NOTICE TO CONTRACTORS
BID #1213-113

"PWP # CC-2013-025

Addendum No. 1

**E. LONG ST CDBG
2013 PEDESTRIAN IMPROVEMENTS
BID ADDENDUM**

**FIGURE
1**

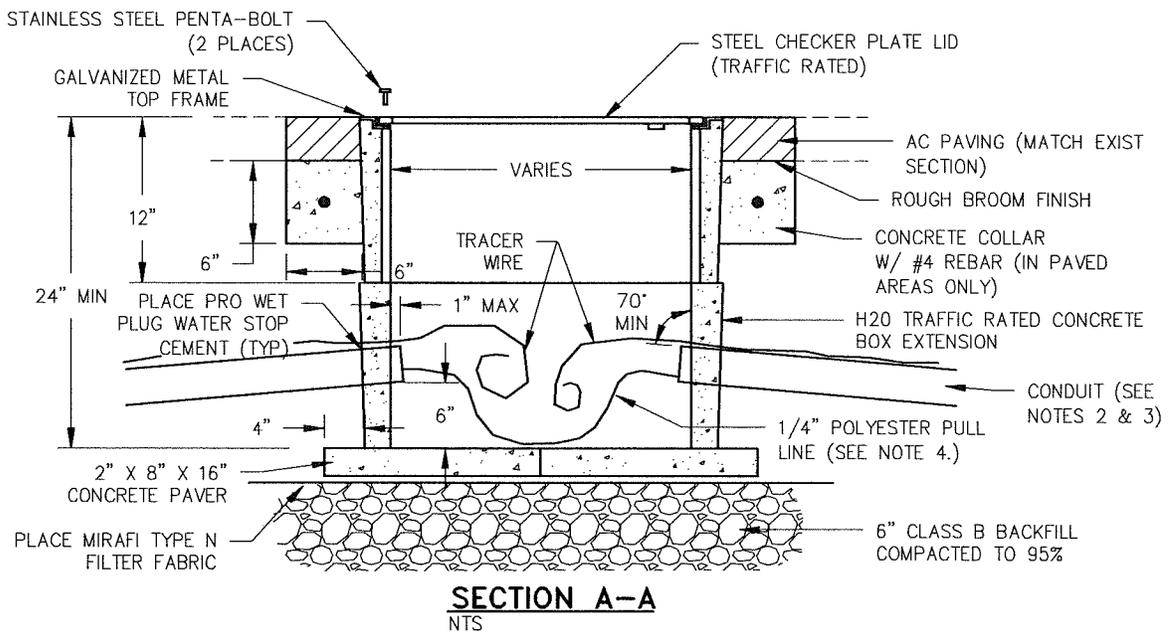
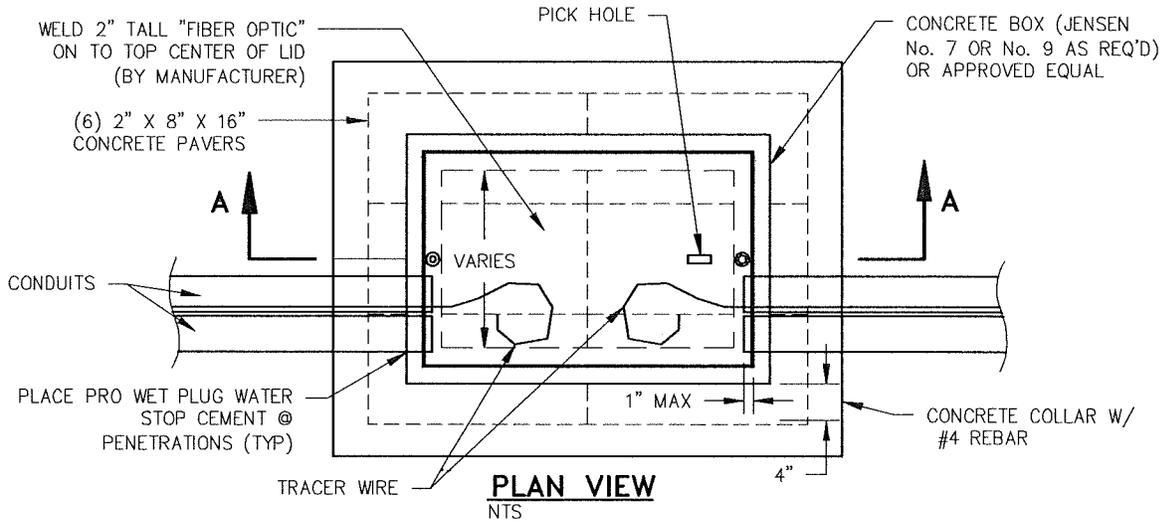
1. At Sta. 10+75 (24' LT) +/- on the plans;
Remove existing fiber optic pull box, connect new conduit to exist
4" conduit, construct 5 LF of 4' wide sidewalk, see attached
drawing.
2. On sheet 10 of the plans replace the following;
Replace detail 2 with the attached revised detail.
3. On BP-10 of the bid document change the following;
Change BP.7 quantity to 6640 SF
Change BP.14 quantity to 200 SF
